DEVIATIONS TO APPROVED PLAN NO. C 536 10 04

**DEVIATIONS TO APPROVED PLAN**  
 C 536/10/04 FOR MR S E A BLEVINS  
 ERF 2070, DURBAN NORTH  
 1 GLENEAGLES DRIVE

**SITE PLAN**

SITE PLAN  
SCALE 1:100

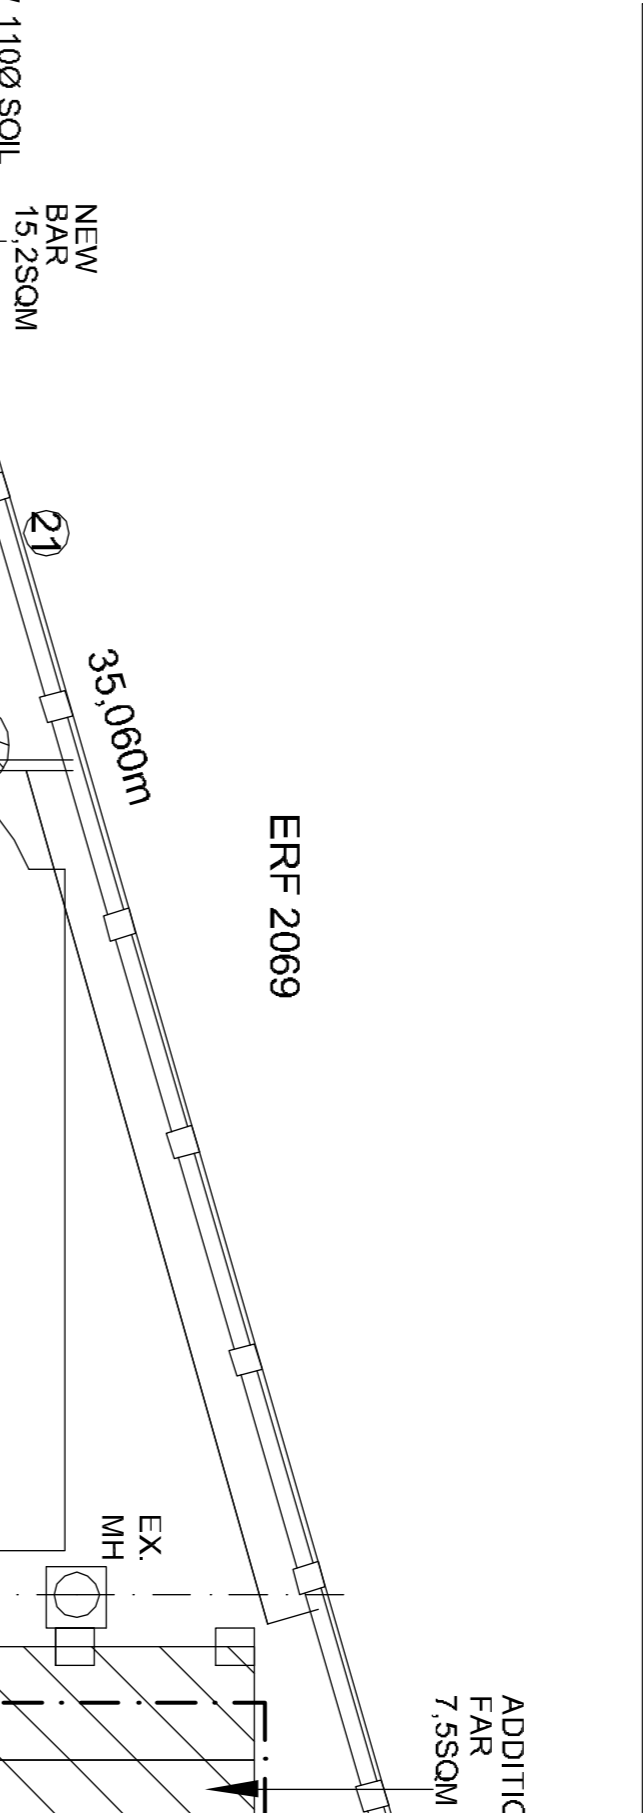
- EXISTING ROOF REPLACED WITH CORRUGATED STEEL SHEETING, COATED SLATE GREY
- NEW FRONT VERANDAH REDUCED IN SIZE, ADDITIONAL AREA USED ON THE NEW BACK VERANDAH

- NEW BEDROOM 1 OMITTED EN-SUITE 2 LAYOUT REVISED
- NEW DRESSING ROOM ADDED
- NEW SINGLE GARAGE CONVERTED TO NEW GUEST SUITE
- NEW STORE CONVERTED TO NEW EN-SUITE FOR NEW GUEST SUITE

- NEW SCULLERY LAUNDRY OMITTED
- BAR ADDED IN PLACE OF NEW STORE, GARAGE DOOR AND WINDOWS OMITTED AND REPLACED WITH A DOUBLE DOOR AND SIDE WINDOW ON THE EAST ELEVATION

- EXISTING SERVANT QUARTERS REVISED WITH A NEW SHOWER AND TOILET AND EXTENDED ROOM AND A ADDED VERANDAH
- NEW VOID USED AS STORE UNDER NEW MASTER BEDROOM, DRESSING ROOM AND NEW EN-SUITE

- FRONT VERANDAH REVISED
- EXISTING WINDOW REPLACED BY A DOOR, STAIRS ADDED
- DOOR OMITTED
- WINDOW IN EXISTING BEDROOM 2 REPLACED WITH A DOOR
- WINDOW IN EXISTING BEDROOM 1 REPLACED WITH A DOOR

- EXISTING KITCHEN WINDOW REVISED
- NEW DRIVEWAY OMITTED
- POOL REPOSITIONED
- EXISTING ROOF TO REMAIN
- NEW BOUNDARY WALL
